Mooney Mite Series M-13  
Service Bulletin No. 14

MOONEY AIRCRAFT, INC.  
M-18 SERVICE LETTER NO. 15

M-18 SERVICE LETTER NO. 16

M-18 SERVICE LETTER NO. (17)

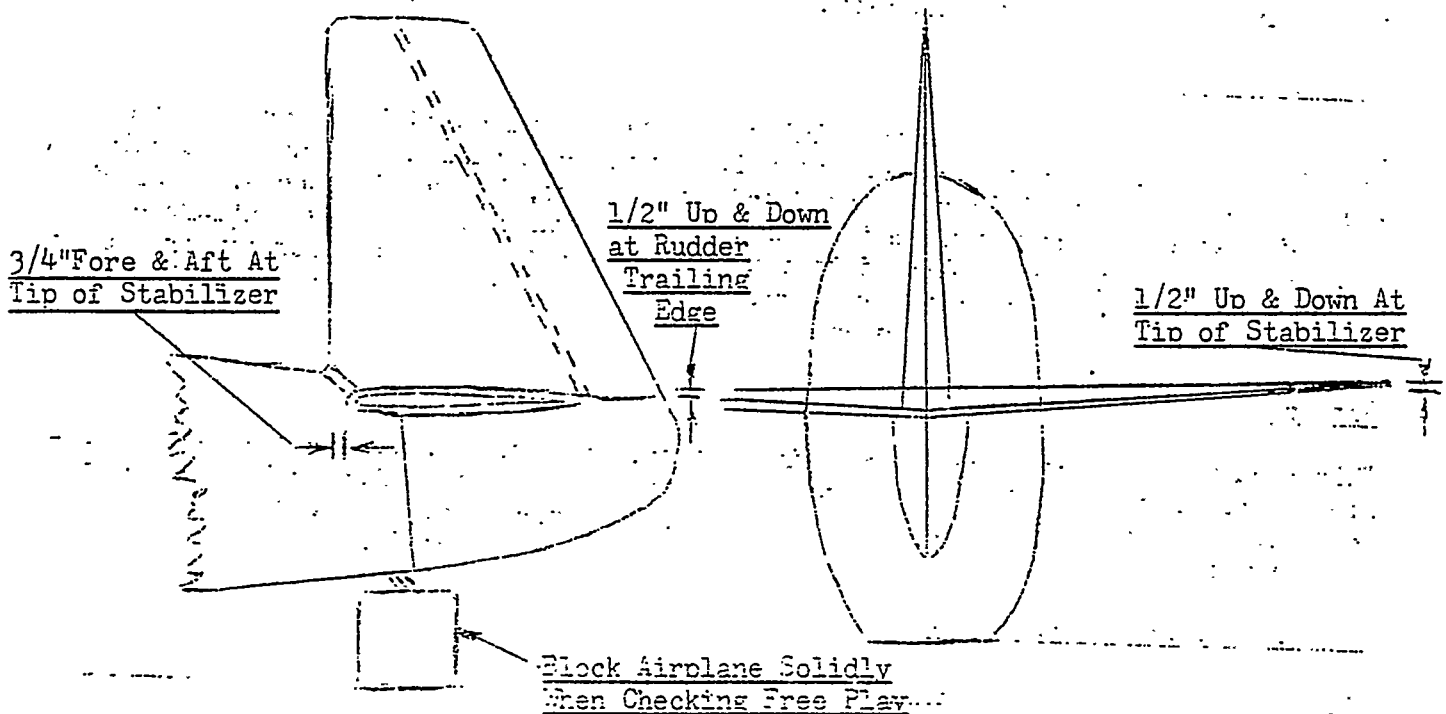
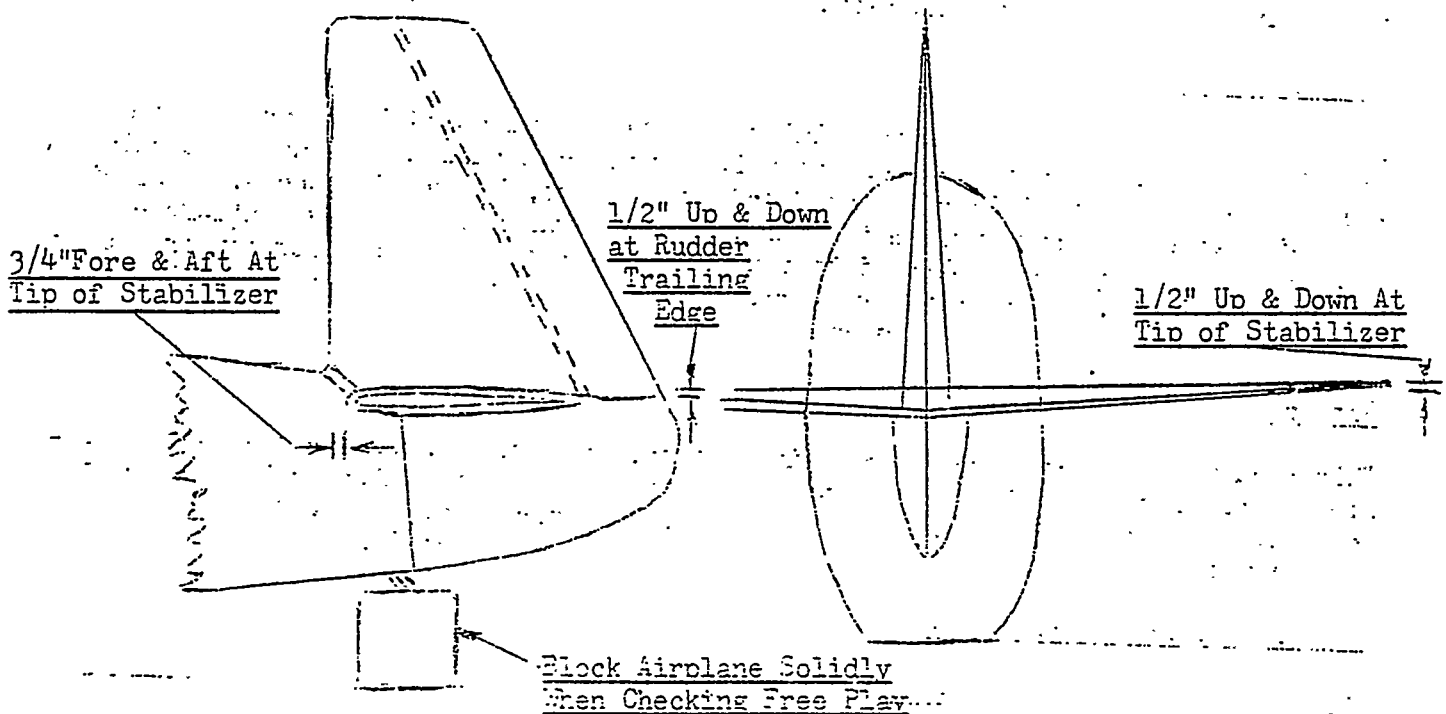
The following sketch illustrates the maximum allowable free play at the specified points.

When checking stabilizer tip free play, either fore and aft or up and down, measure free play on the opposite tip from where the stabilizer is moved by application of hand pressure. This eliminates errors in measuring due to bending deflections of the stabilizer itself.

Sketch A

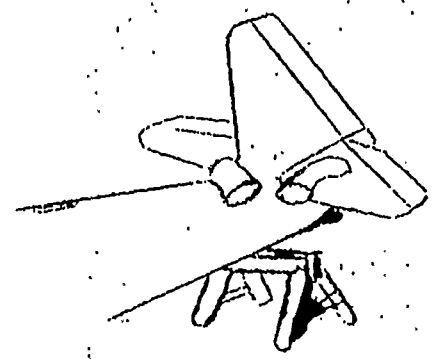
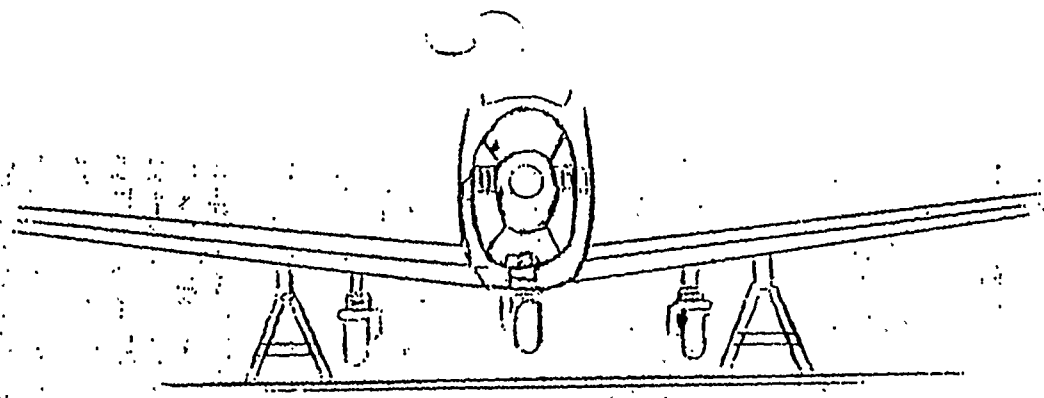
Elevate the aircraft on three suitable saw-horses. Two of which are placed under the wing just outboard of each main gear, between the third and fourth ribs, approximately three feet from the fuselage skin. The saw-horses should be of sufficient length to extend from slightly behind the rear spar to the front spar, and preferably past the leading edge of the wing. This length is desired to minimize damage to flaps and skin on the leading edge should the aircraft accidentally be rolled back or forward on the front spar while elevated on the horses. Should the tail be pushed down too far, a saw-horse extended behind the rear spar would rupture the flap fabric. Should the nose drop, rolling the aircraft onto the leading edge, the end of a saw-horse that did not extend beyond the spar would be pushed thru the leading edge skin. See Sketch A for elevation details.

Sketch B

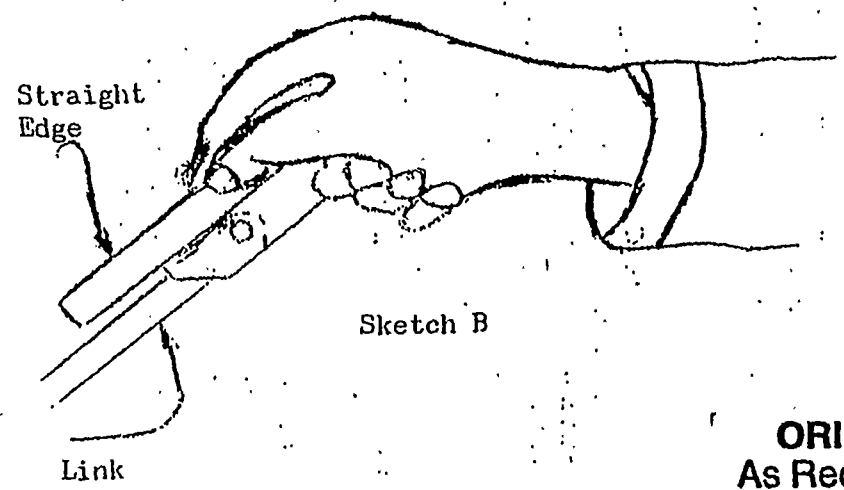
It has been found absolutely necessary for the over-center locks to be in the over-center position and that considerable force is required to change this position. To check whether lock is over center lay a short straight edge along the top side of the lock as shown in Sketch B.

When the straight edge and link are parallel the lock is over center. The locks are held in this position by the force required to place the retracting lever in the "Gear Down" position. On new airplanes or ones in which new parts are installed the force at the top of the lever with the main gears disconnected from the retracting truss on which the lever is mounted should be 18 to 24 lbs. The force should be 2 lbs. additional with all three gears connected. The nose gear should be checked alone first, on which greater or less force is controlled by adding or removing washers on the forward side of the handle lock down plate as shown in Sketch C.

Figure 1

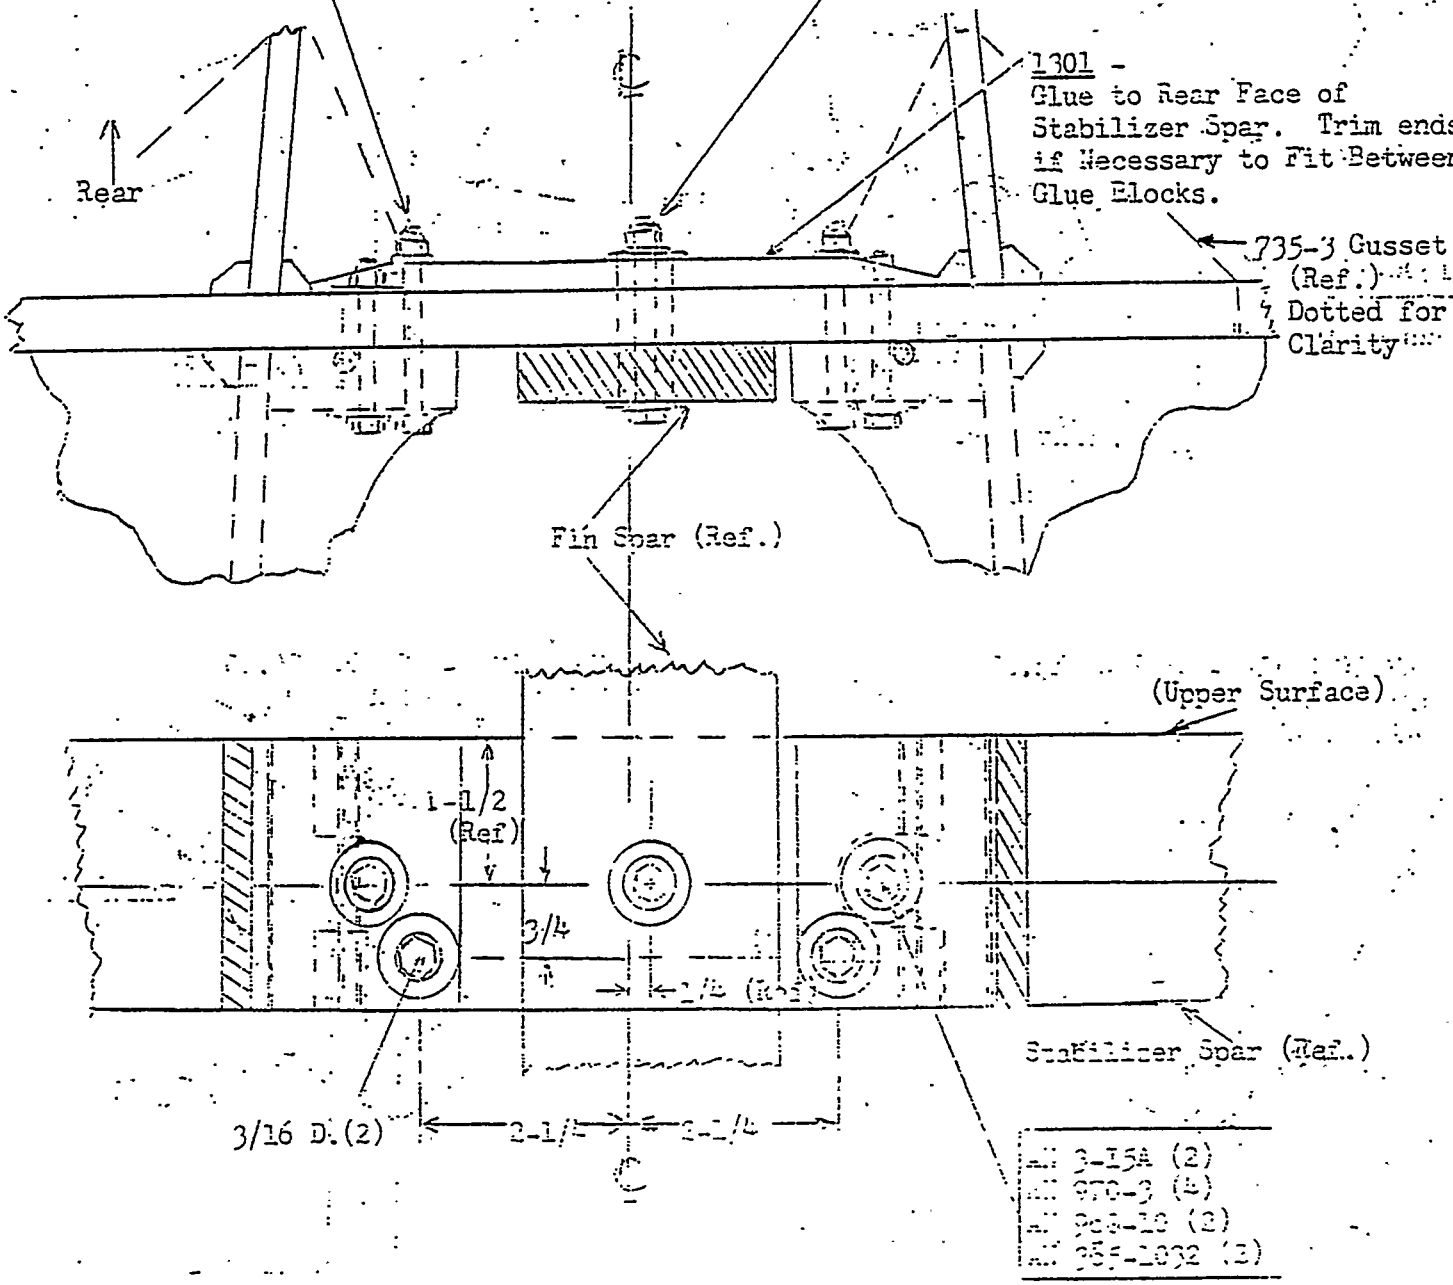
5. Any defective wood parts shall be replaced or repaired in accordance with Civil Aeronautics Manual 18 and/or manufacturers recommendations. When it is determined that the fin and horizontal stabilizer are in satisfactory condition, the rework shown in Figures 1 and 2 shall be accomplished. The glue used shall be a urea-formaldehyde type such as Melwood or Cascamite. Parts for the required rework are available at no cost. Order Kit 5118-16 from the Spare Parts Department of Mooney Aircraft, Inc.

FIG. 1

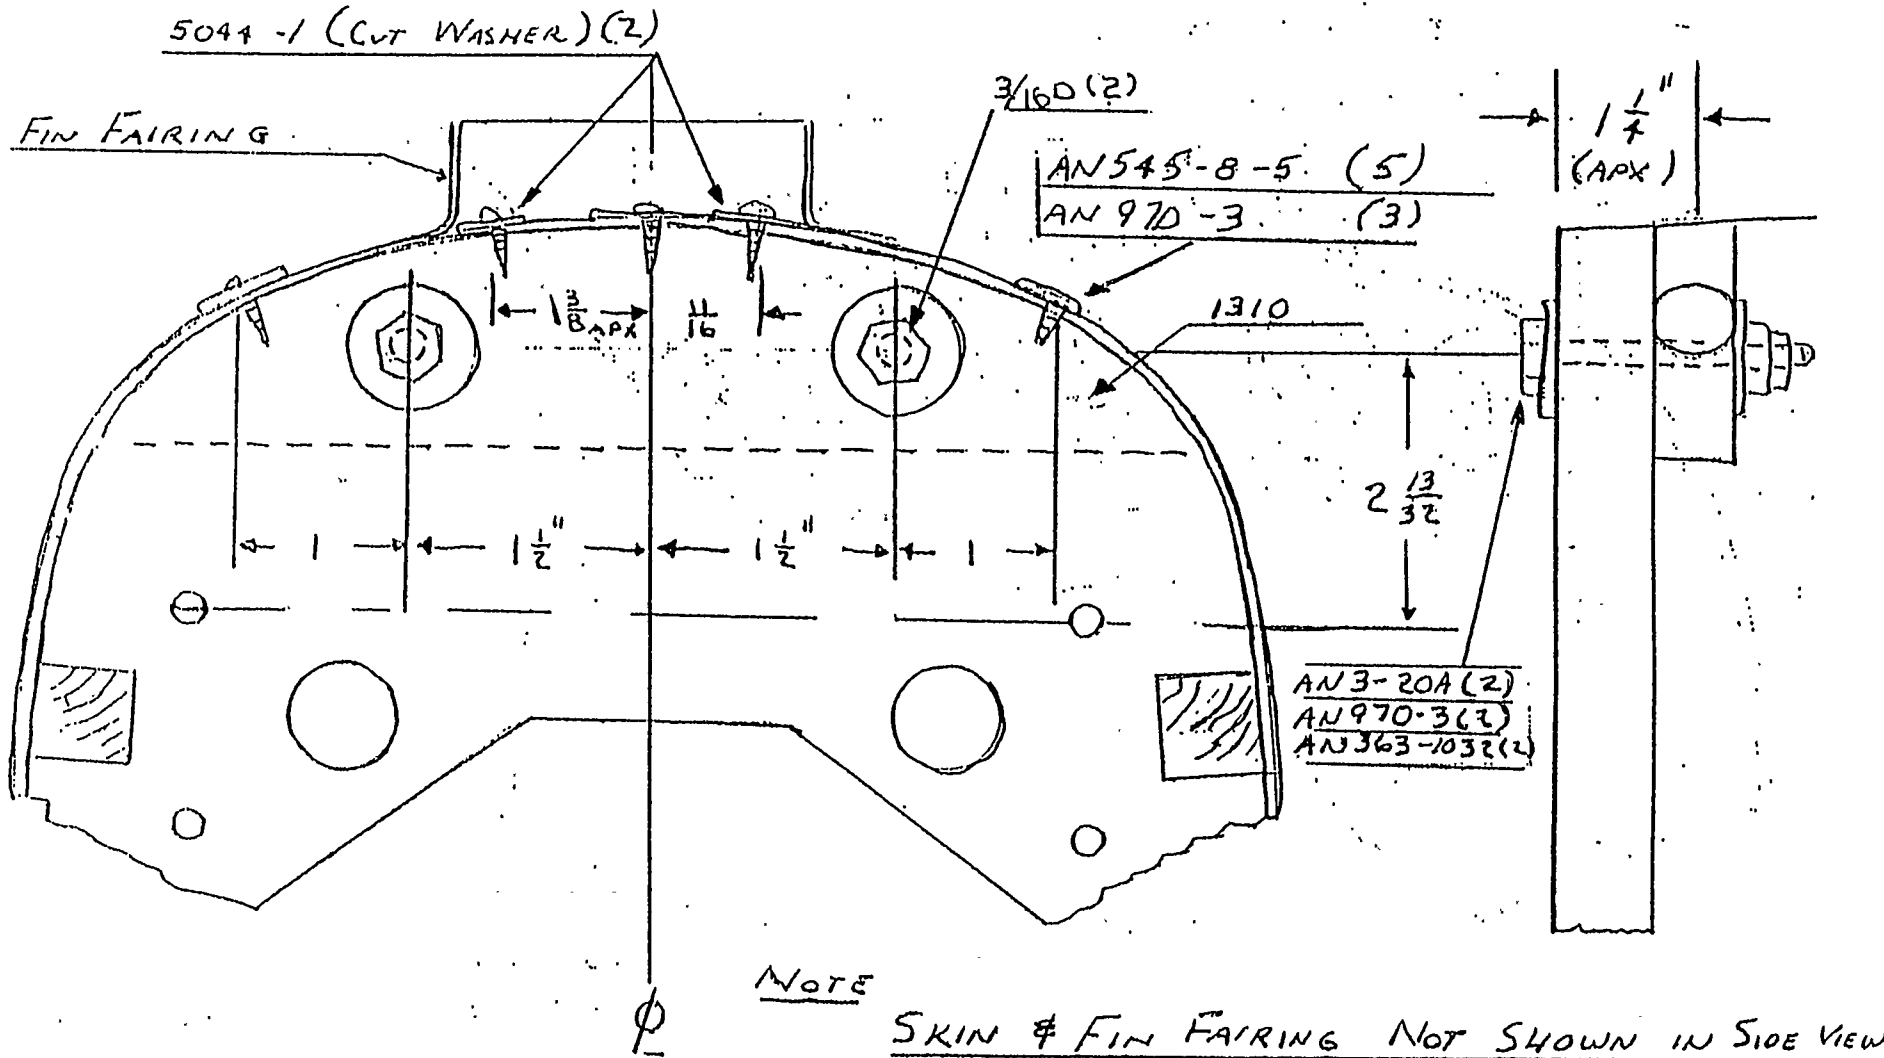
1. All airplanes having the defect described in Item 1 of the Introduction are to be repaired in accordance with Figure 1 or Figure 2 depending on the type of elevator control system.
2. Order Rework Kit SL 18-17-1.

FIG. 3

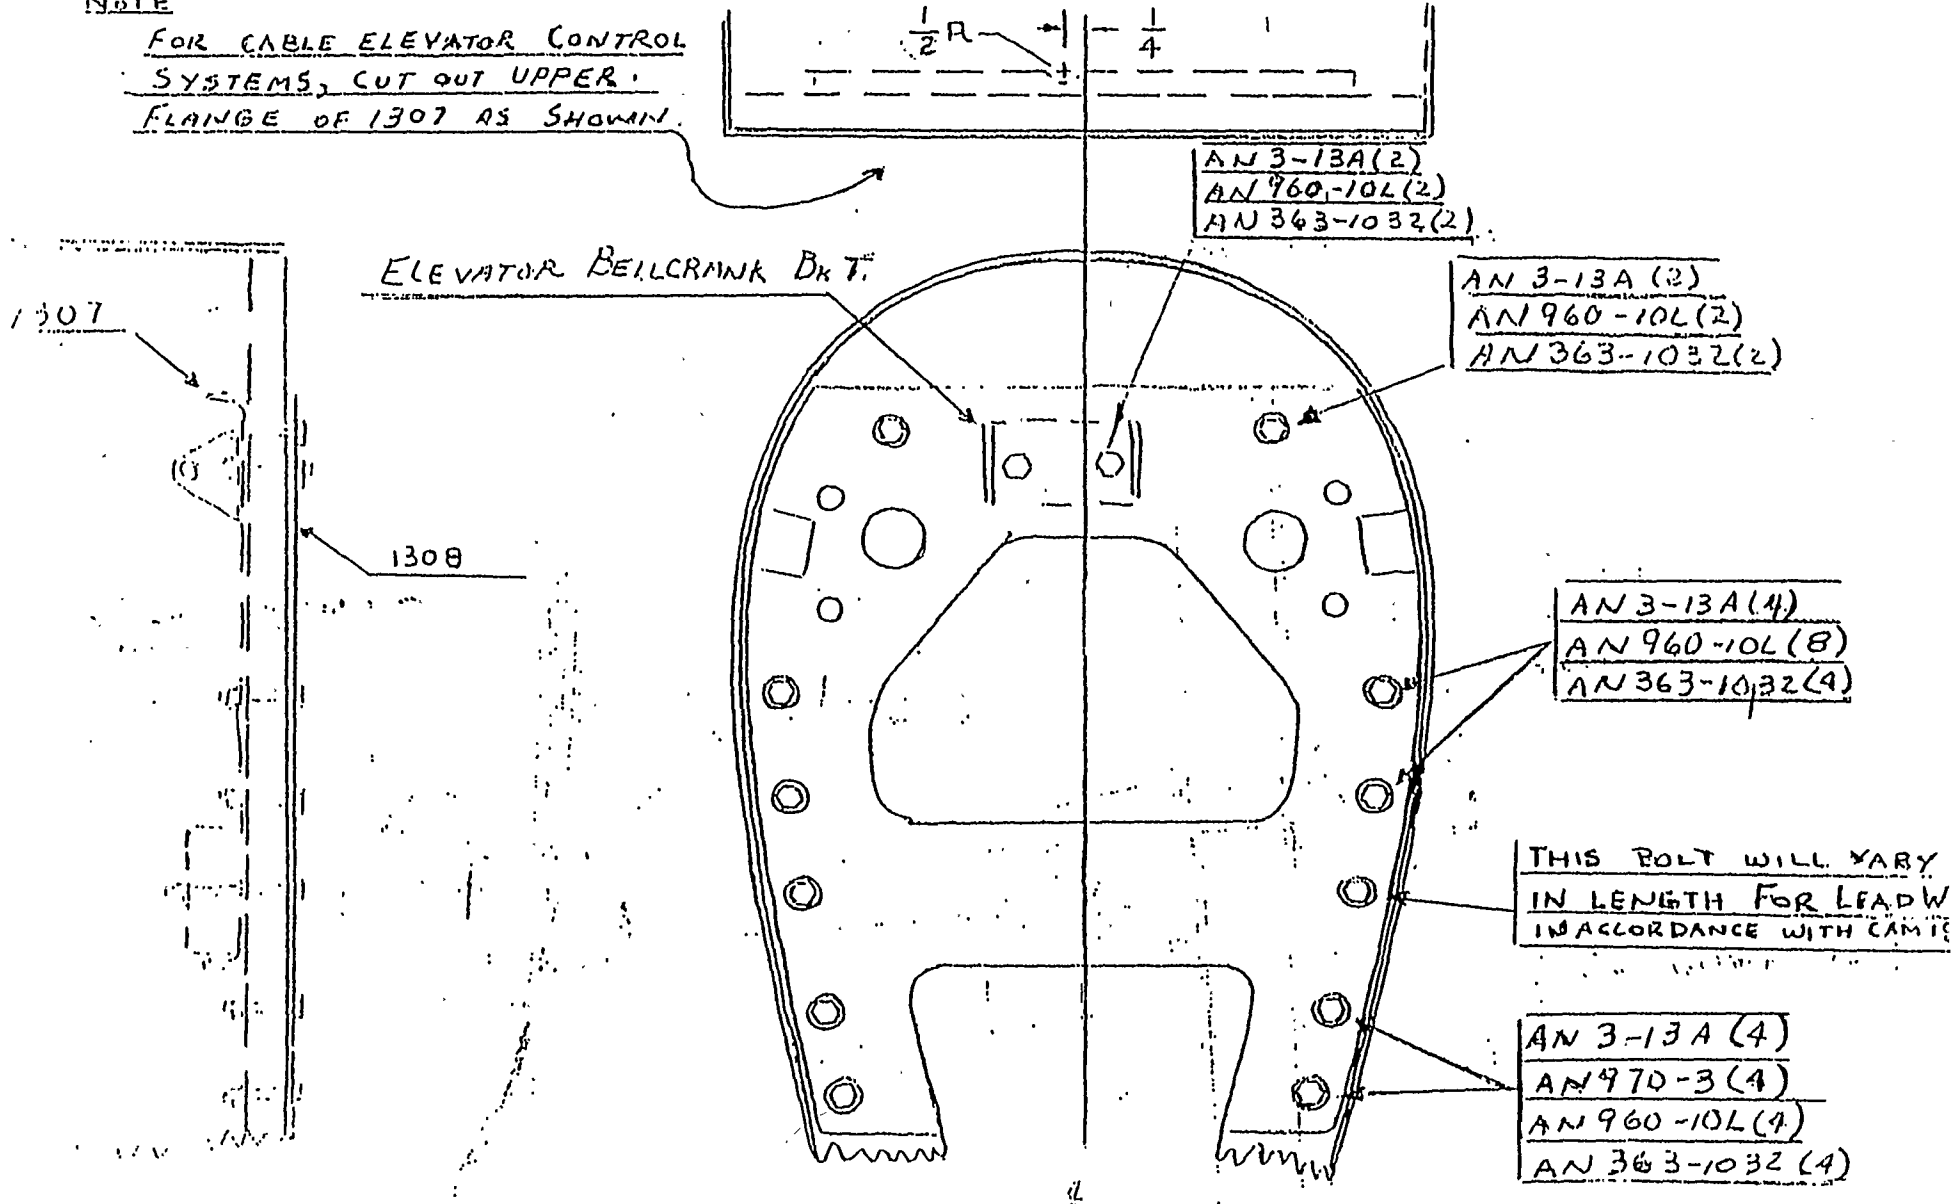
FOR CABLE ELEVATOR CONTROL  
SYSTEMS, CUT OUT UPPER  
FLANGE OF 1307 AS SHOWN.
